**BCA & DDA ASSESSMENT REPORT**

*Design Development*

**Blayney MPS**

Reference: 220216

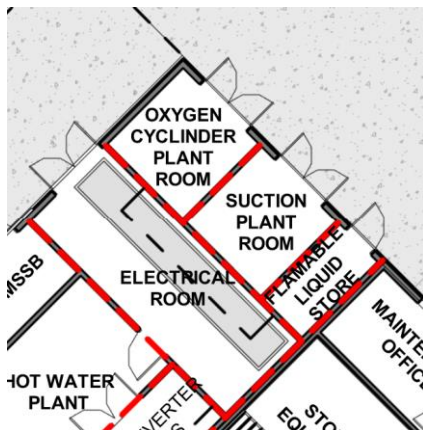
1. Purlins passing through the fire wall above the blade wall between RAC and IPU.
2. The common detail (below) where purlins do not pass through but the a structure does passing through to connect to columns within the fire wall.

Jacobs structural engineer has confirmed that 'failure of the structure on one side of the wall will not impact the performance of the fire wall, or the integrity of the structure on the other side. This is as the fire wall can be supported independently by structure either side (e.g. if structure on one side fails, the intact structure on the other side provides support and vice versa).' – Aconex corro JACOBS-GCOR-000358 dated 24/08/23.

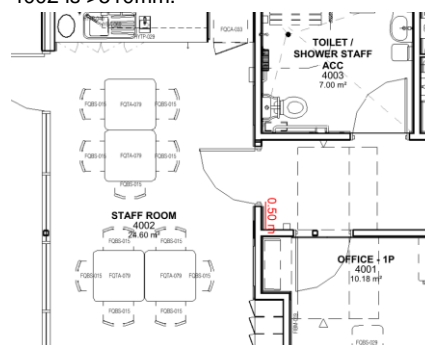
Include dimensions on the plans to verify if the latch side clearance into the Staff Room 4002 is >510mm.

**AS1428.6**  
**Cl.2.2**  
Parking  
Spaces

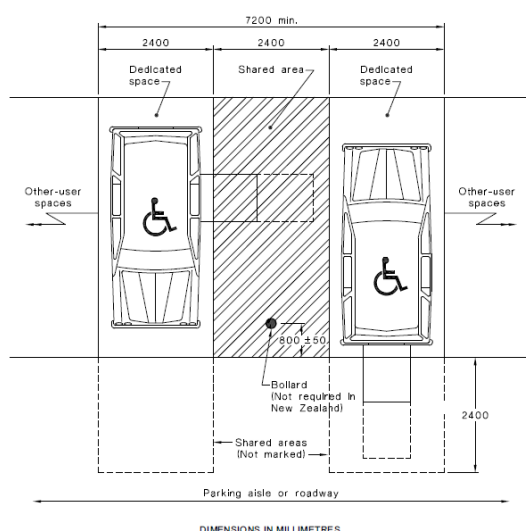
There is no detailed drawing of the accessible carparking area.

Detail all gradients around accessible carparking areas for the on-grade carpark. This is not shown on the landscape or civil plans.

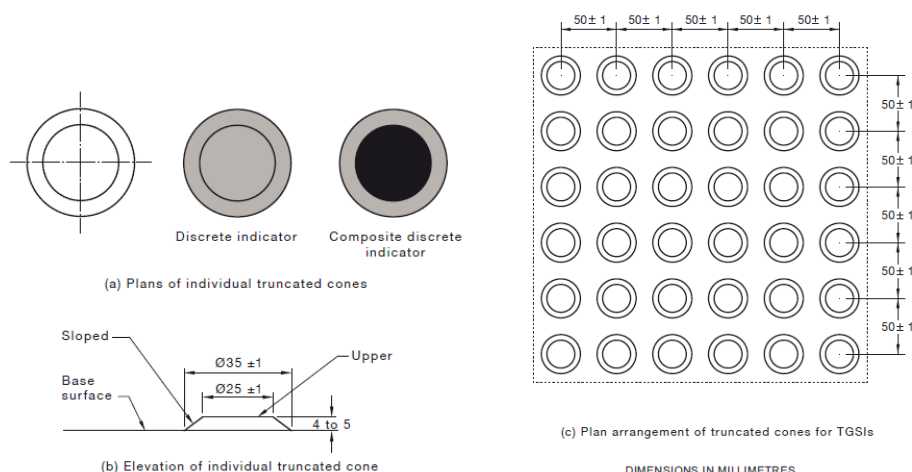
TGSI's are not detailed on the landscaping plans. TGSI's need to be provided at:

**P RLS - TOILET STAFF PLAN**  
1 : 50

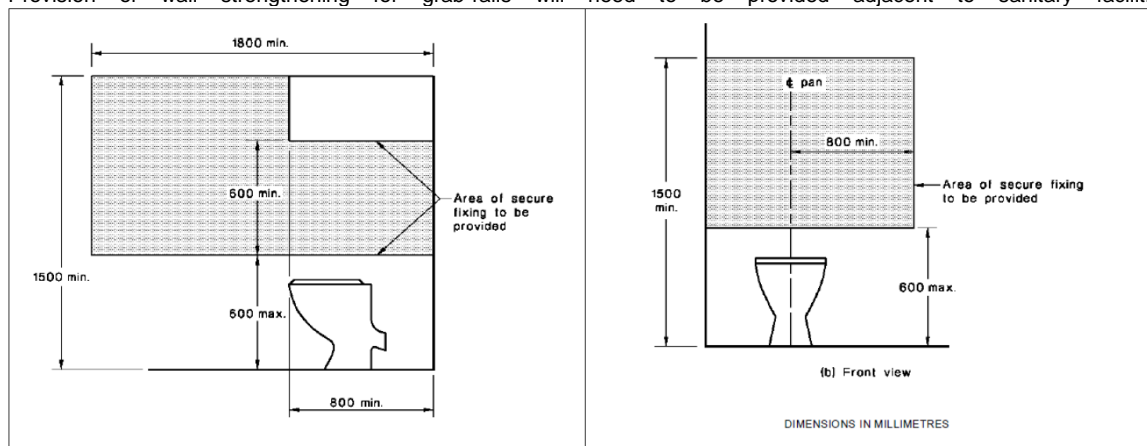
The RLS plans of accessible WC's show the set-out of fixtures and fittings. Specific dimensions should be included to ensure compliance is met.

Details to be included in the design at detailed design stage
